Revised September 2020

Safety Recall W44 / NHTSA 20V-207 Bed Step

NOTE: The service procedure and labor time has changed. Now replace the bed step brace rather than removing the bed step. Photos and manual claim submissions are no longer required.

Figure 1 – Old Bed Step Brace

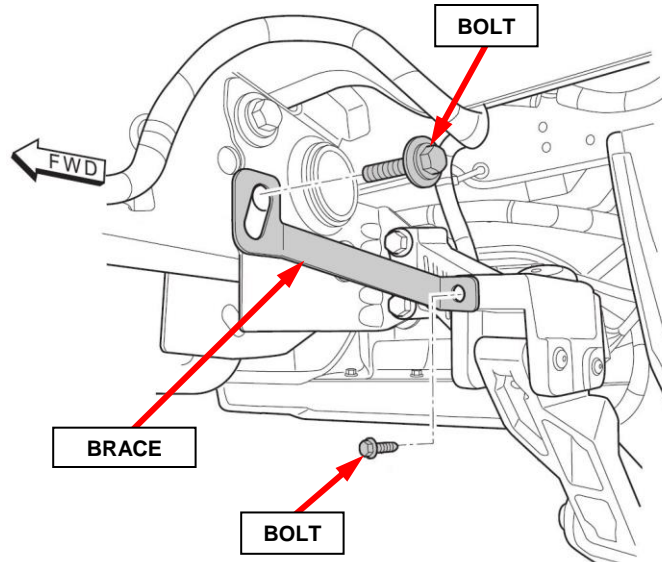
2. Remove and **DISCARD** the two bolts securing the bed step brace (Figure 1).

3. Remove the recalled bed step brace then render it unusable and **DISCARD**. (Figure 1).

Figure 3 – New Bed Step Brace

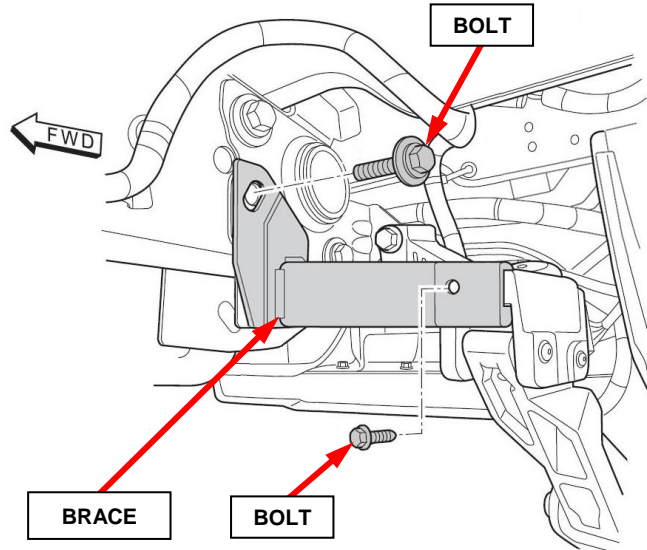
5. Install the **NEW** bed step brace (Figure 3).

6. Loose install the **NEW** M8 bolt then the **NEW** M16 bolt included in the campaign kit (Figure 3).

NOTE: Do NOT tighten the bolts.

Figure 4 – Bolt Tightening Sequence

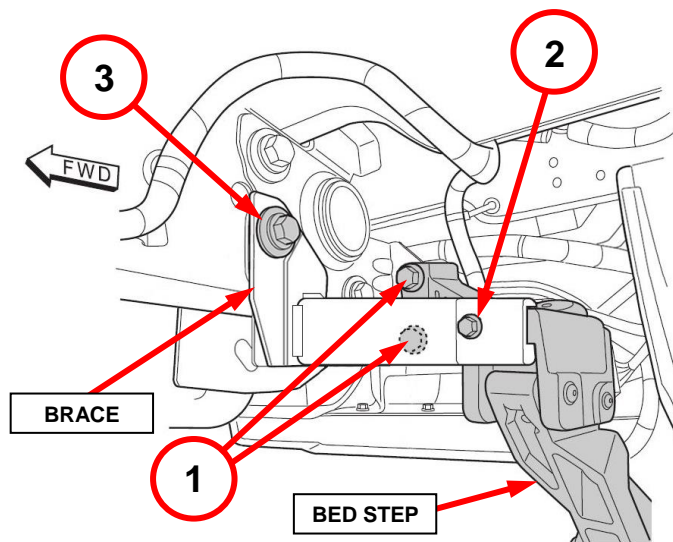
7. Tighten the bolts in the following sequence (Figure 4):

NOTE: After tightening the bed step bolts (1) and before tightening the bracket bolts (2, 3) check for clearance between bed step and bumper with bed step in the stowed position. Adjust as necessary to avoid any contact.

- (1) M10 bed step bolts.
68 N·m (50 ft. lbs.)
- (2) M8 brace bolt.
22.5 N·m (16.5 ft. lbs.)
- (3) M16 brace bolt.
190 N·m (140 ft. lbs.)
